**TOWN OF BAY HARBOR ISLANDS
MORRIS N. BROAD COMMUNITY CENTER
1175 95TH STREET
BAY HARBOR ISLANDS, FL 33154**

Subject: Site Development Plan Application (#1 Review)
Aire Boutique Apartment Building
9950 East Bay Harbor Drive – 8 DU Multifamily Complex
Bay Harbor Islands Acct. No. SPR2025-000016
MMPA Acct. No. 01-0702-1207

MMPA recommends the Development Review Committee (DRC) **DEFER** action on the proposed Site Development Plan application at this time to allow the applicant's design team to address the listed comments. The submittal package has several design / Code violation issues, some of the plans are inadequate or missing and a few other items need to be corrected.

Following are comments based on the plans dated April 11th, 2025, submitted to the Town's DRC for consideration:

02 SITE PLAN
Scale: 1/8" = 1'

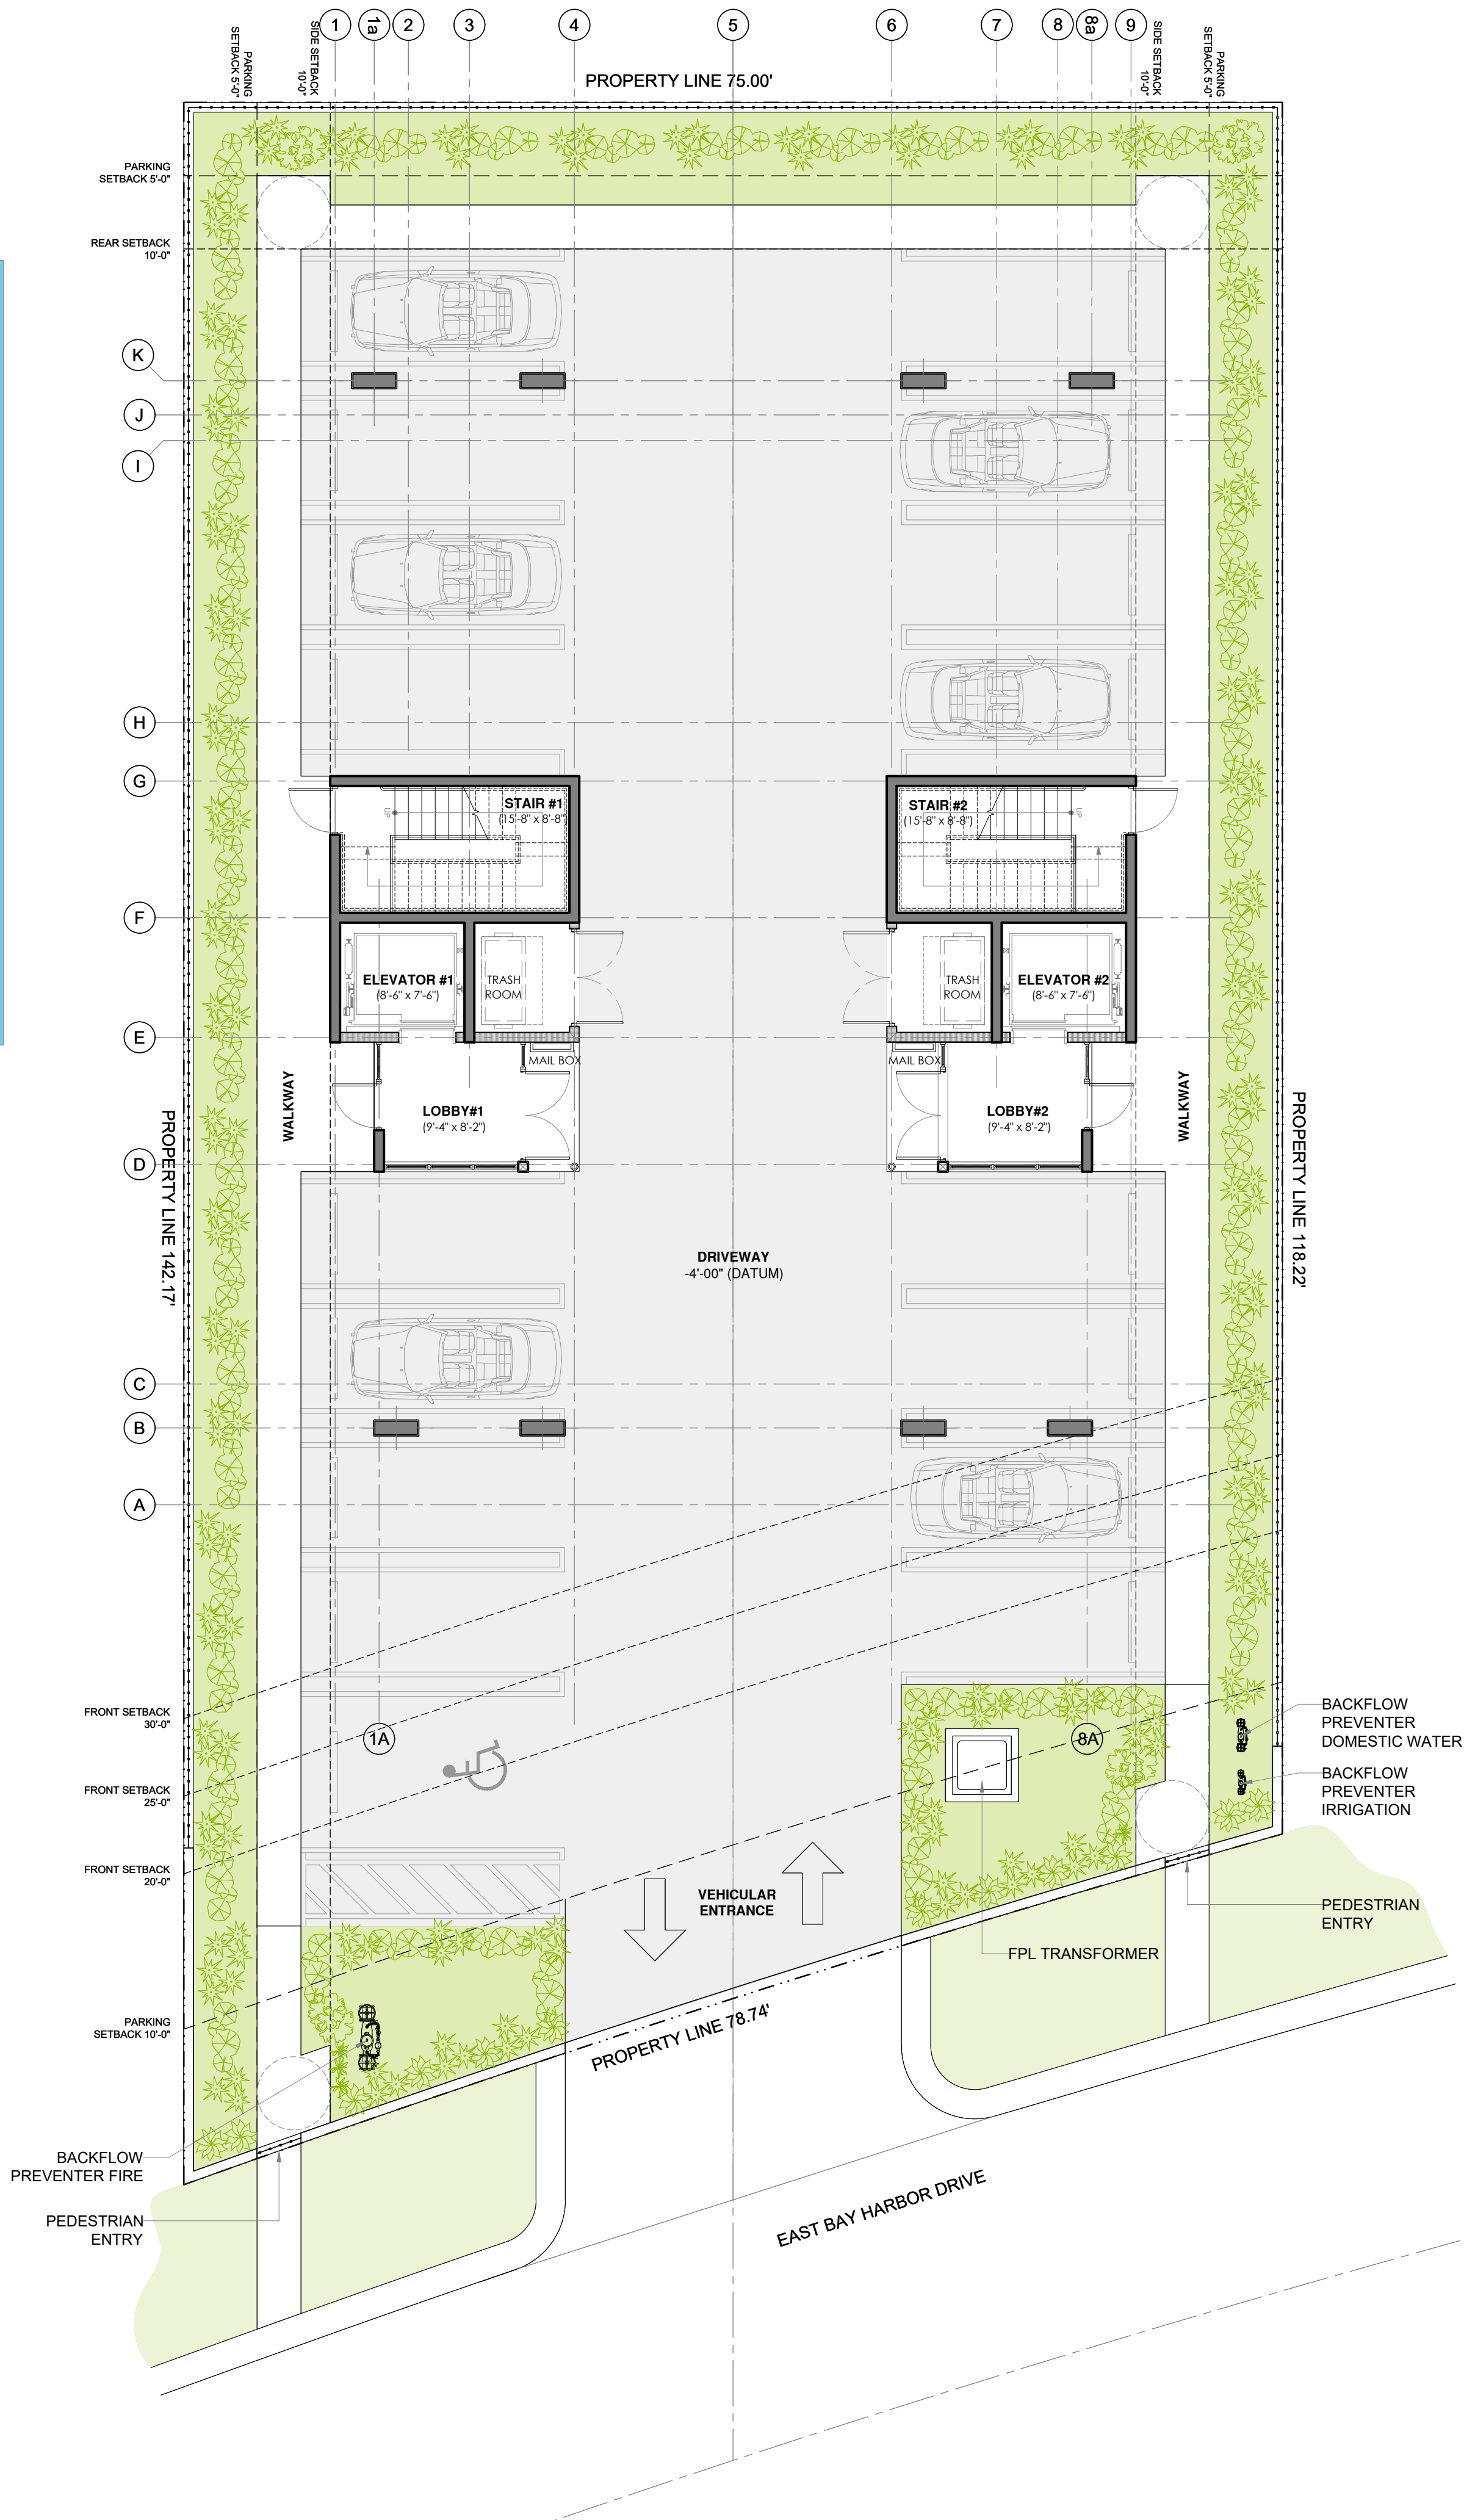
- 2) On Sheet AO-01 and Sheet A1.01 the Site Plan illustrations need many additional dimensional notations for proposed site features (side yard landscape area width / walkway widths / etc.) to help determine Code compliance. See Sec. 23-12 for applicable setbacks.

- 3) On Sheet AO.01 in the Zoning Calculation Table the maximum height allowed should state 65'-0" above BFE + 1' FBC Freeboard. We believe the 9.0' listed is just the current FEMA FIRM data (does not include FBC freeboard). Revise.

- 14) The Site Plan has the following issues:
 - a. The Site Plan appears to show proposed perimeter fences & walls; however, there is no design detail provided. Please provide details of all proposed fences & walls along the property lines. No fence / wall can be placed closer than 2' from the front property line. Retaining walls and filling of the grade is regulated. See Section 23-12(22) for the LDRs on fences & walls (max. hgt. 6' from adjoining lot grade).

- e. The Town Code requires a min. 10' wide landscape between a front property line and any on-site pavement. No dimensions are shown on the site plan Sheets; however, a dimension of only 8'-8" is shown on one sheet. The DRB has the ability to grant minor waivers, but this has not been approved recently.

GROUND FLOOR LANDSCAPE PLAN
SCALE: 1" = 10'

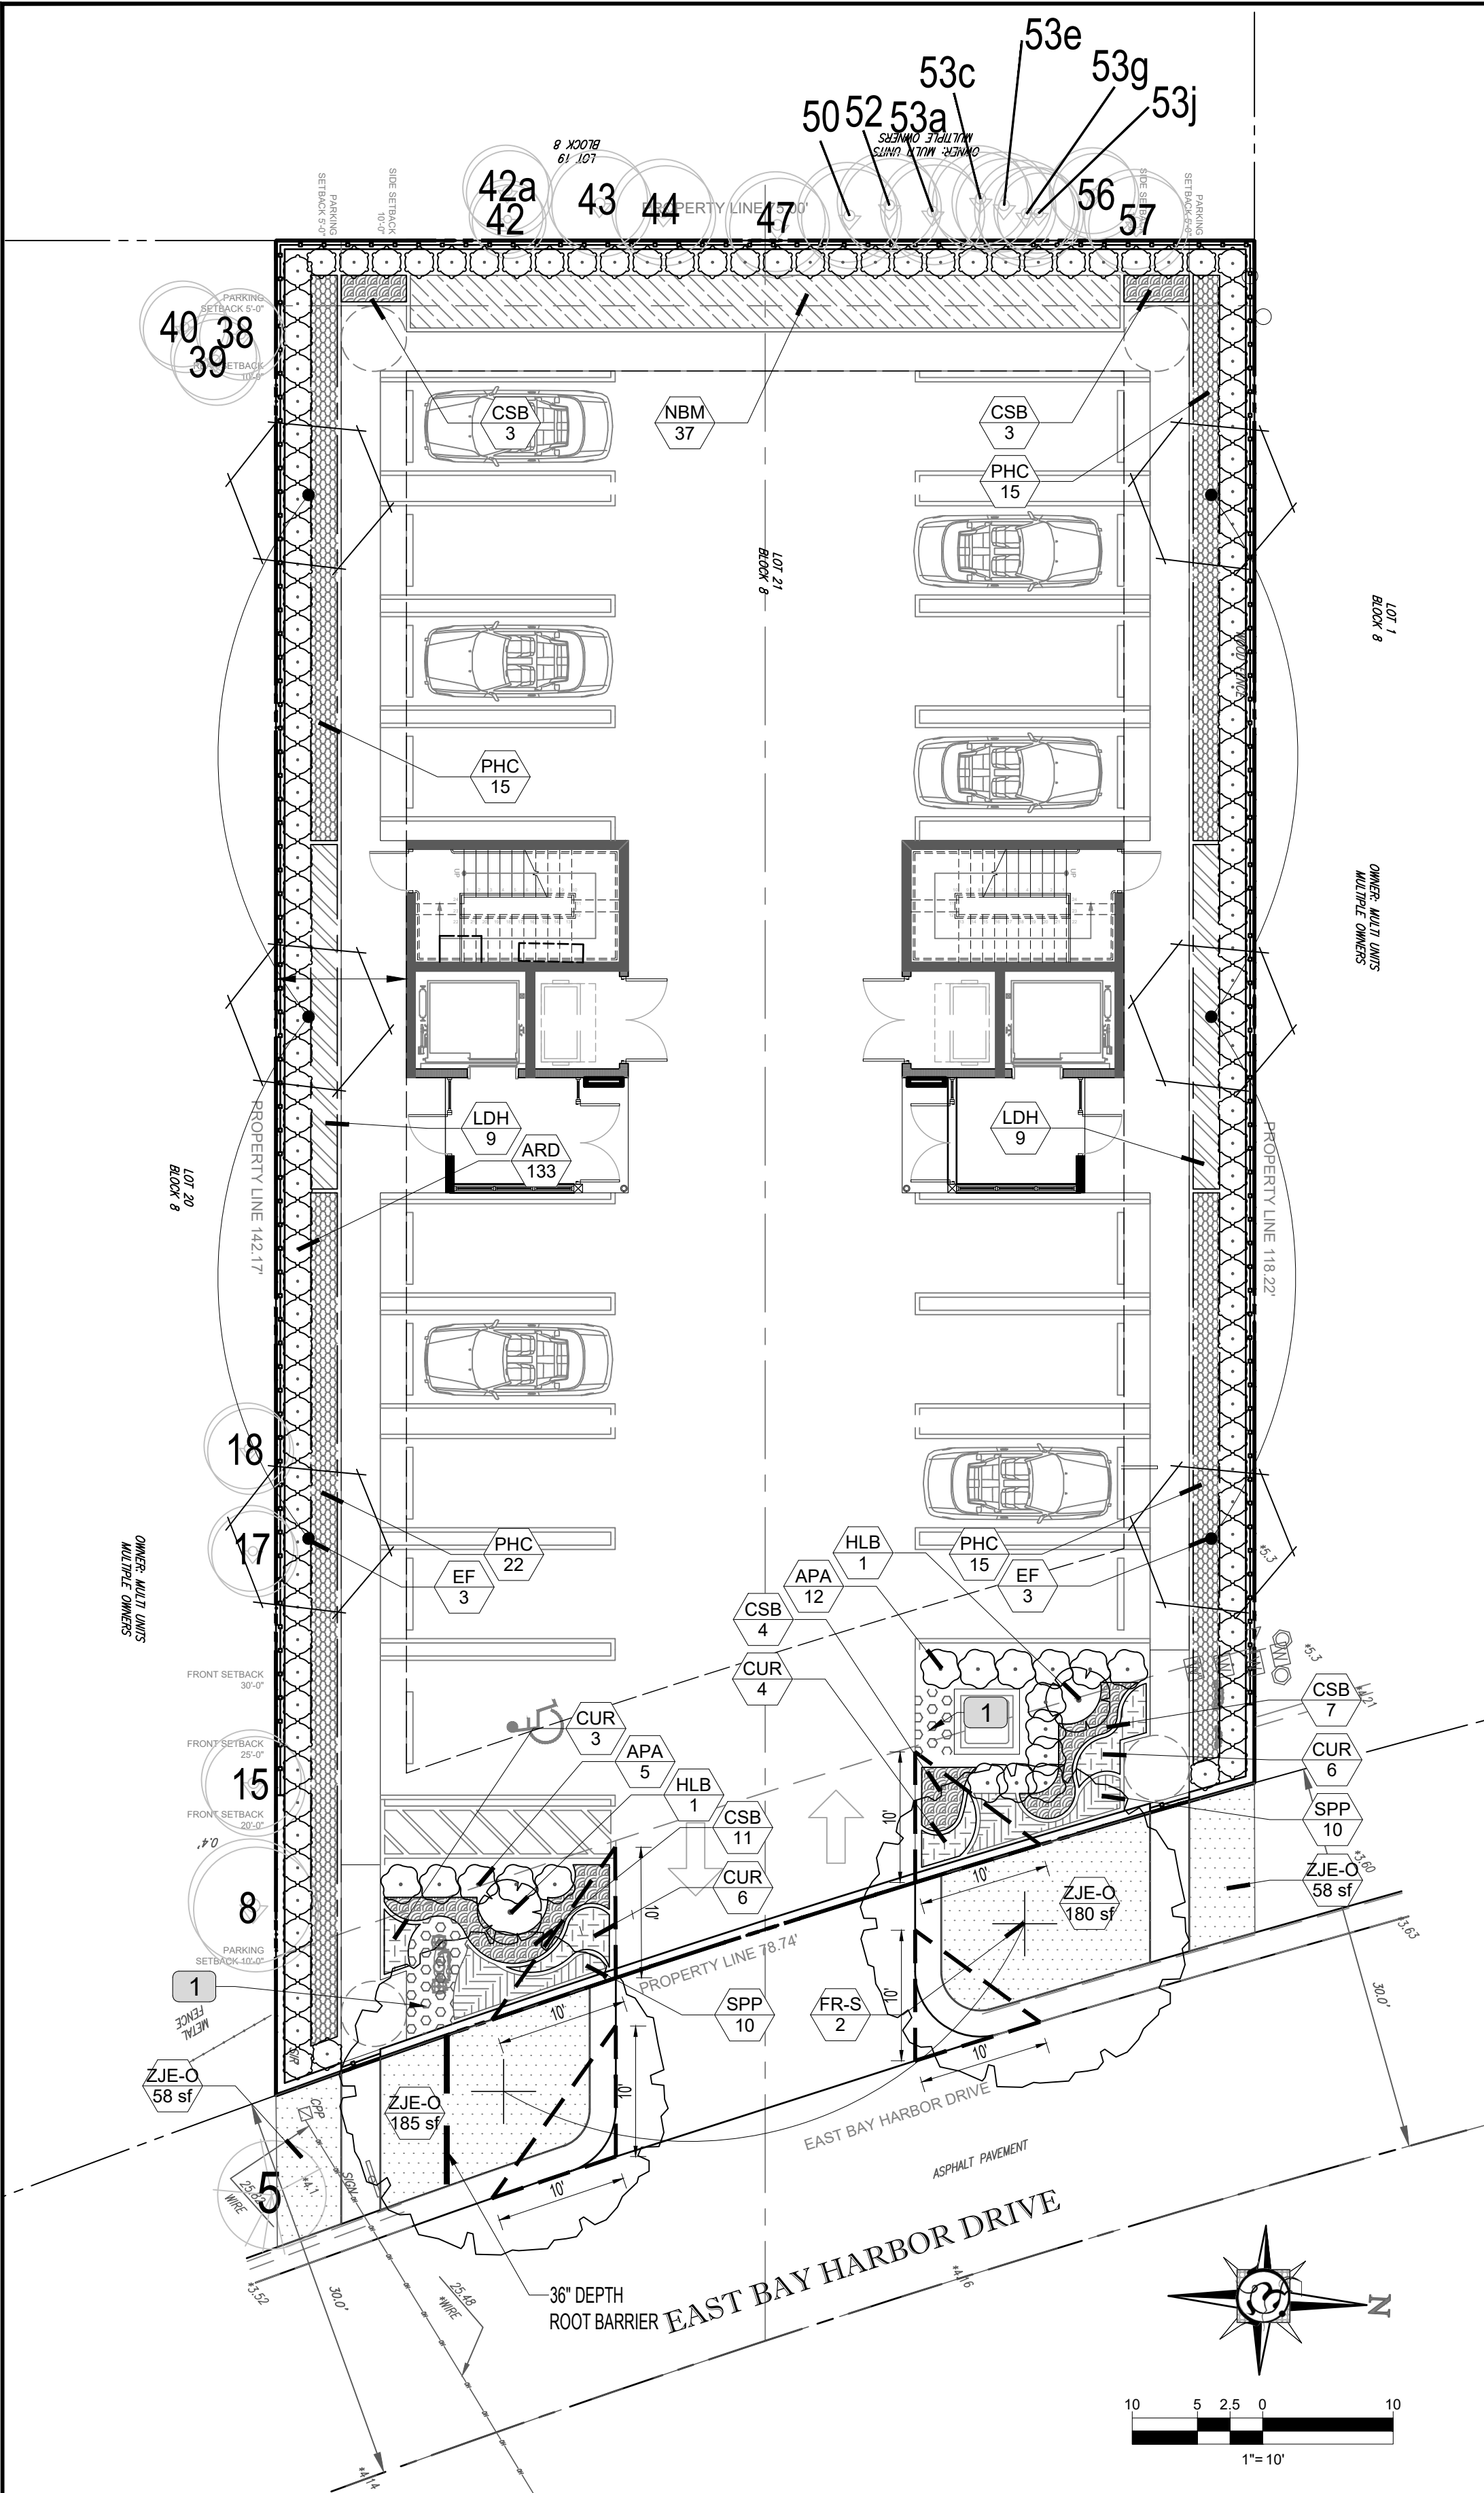
- 9) The Landscape Plans have an incorrect Landscape Calculation Table. This appears to be for the MD Chapter 18A minimum countywide standards. The Town adopted a Supplemental Landscape Code many years ago with more stringent requirements based on the community high quality and coastal location. See Section 24-16. Also see the attached Town Landscape Table to be used. Insert the current table and revise the design accordingly. The current Landscape Plan does not meet the Town's Landscaping requirements.

- 22) Landscape Plans have the following comment:
- a. The Landscape Plan needs to be revised to accurately reflect the Town's Supplemental Landscape Code requirements (Sec. 24-16) (% of native species, % of drought tolerant species, % of palms allowed, etc.) in addition to the Miami-Dade County min. requirements.

- b. The plan does not provide the correct required street trees per Miami-Dade Ch. 18B and the Town's adopted master Street Tree Plan. East Bay Harbor Drive at this location requires Green Buttonwood trees (plans show 2 Rusty Fig trees). The street tree shall be a min. 15' in overall height with at least six feet of clear wood before branching, a min. caliper of two and one-half inches and shall be planted to meet the Miami- Dade County min. criteria of 35 feet on average separation but not shall exceed 40' on-center.
